Model: PRIPORT OPAL/OPAL-MC		Date: 25-Dec-03	No: R-C593-001
Subject: New model Opal-MC information		Prepared by: A. Yoshida, Priport Service Planning Section	
Classification:	<input type="checkbox"/> Troubleshooting <input type="checkbox"/> Mechanical <input type="checkbox"/> Paper path <input checked="" type="checkbox"/> Other (New machine information)	<input type="checkbox"/> Part information <input type="checkbox"/> Electrical <input type="checkbox"/> Transmit/receive	<input type="checkbox"/> Action required <input type="checkbox"/> Service manual revision <input type="checkbox"/> Retrofit information
Model Name: TC-II

Model: PRIPORT OPAL/OPAL-MC/HQ-OPAL		Date: 20-Jan-06	No: R-C593-002
Subject: Drive Gear Damage		Prepared by: A. Yoshida, Priport Service Planning Section	
Classification:	<input checked="" type="checkbox"/> Troubleshooting <input type="checkbox"/> Mechanical <input type="checkbox"/> Paper path <input type="checkbox"/> Other ()	<input type="checkbox"/> Part information <input type="checkbox"/> Electrical <input type="checkbox"/> Transmit/receive	<input type="checkbox"/> Action required <input type="checkbox"/> Service manual revision <input type="checkbox"/> Retro

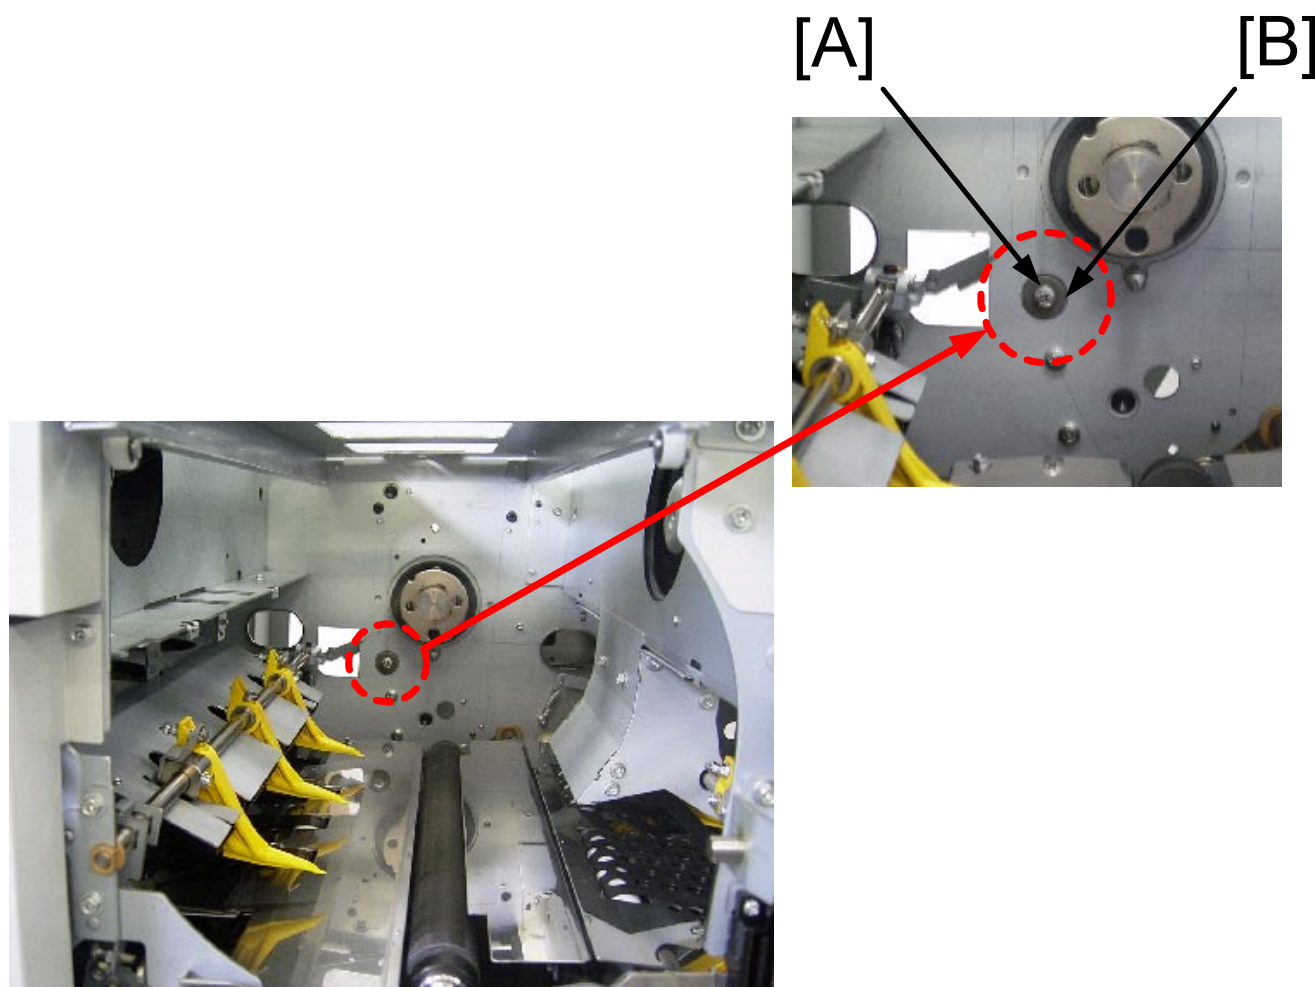
The drive gear [A] for the relay transport unit and paper delivery section is damaged during printing.

The drive gear [A] comes loose from the ball bearing.

- 1) The length of the gear shaft was decreased by 2mm
- 2) A washer was added between the gear and e-ring.

Install the new gear shaft and the washer listed in MB #MC593006.

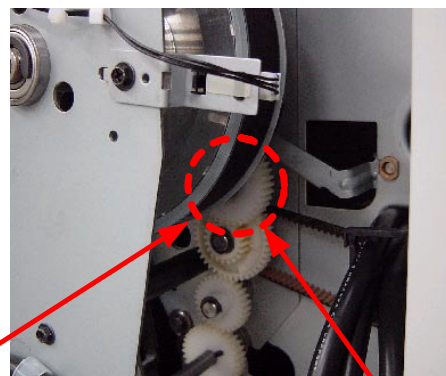
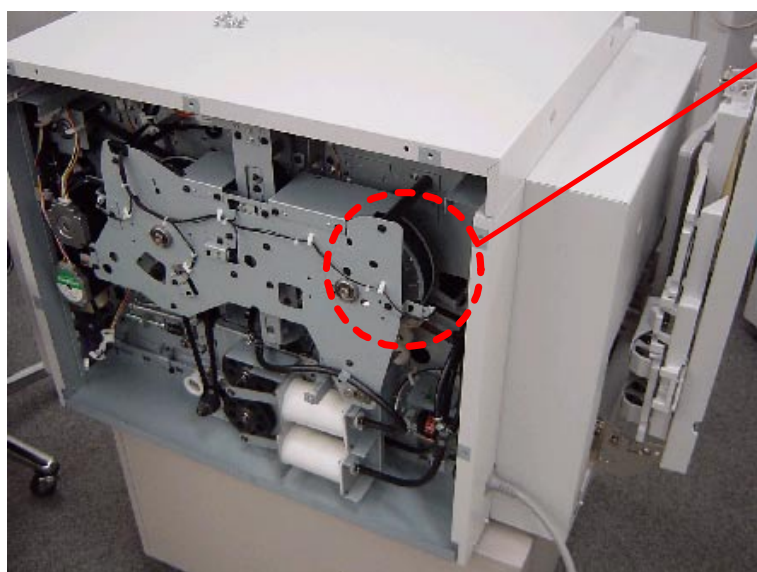
1. Remove the 2nd drum.
2. Turn off the main power switch.
3. Remove the rear cover (⌀ x 11).
4. Open the front door.
5. Remove the screw [A] and the spacer [B] from the mainframe.

6. Remove the drive gear assembly [C].

7. Install the new gear shaft and washer.
